Bulletin No: 22KARTGUARD
Release Date: 10/1/2022
Effective Date: 10/1/2022
Supersedes: N/A
Supplement: 19KARTHAIR
Completion Date: See text
Page: 1 of 1

SAFETY ALERT

Ride Name: Go-Kart

Model: Eagle, Double Eagle, F22, F22 Double (Honda GX-240 & GX-270 engines only).

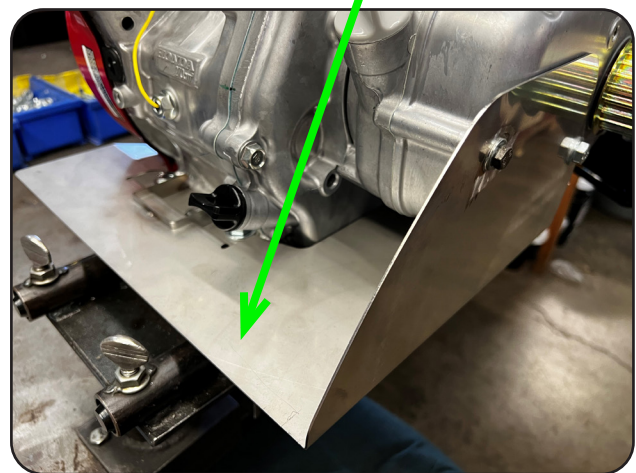
Installation of J&J engine guard assembly and axle drive cover guard assembly.

Axle drive cover guard assembly part # 1-60-A3020

Engine guard assembly part # 1-61-A0013
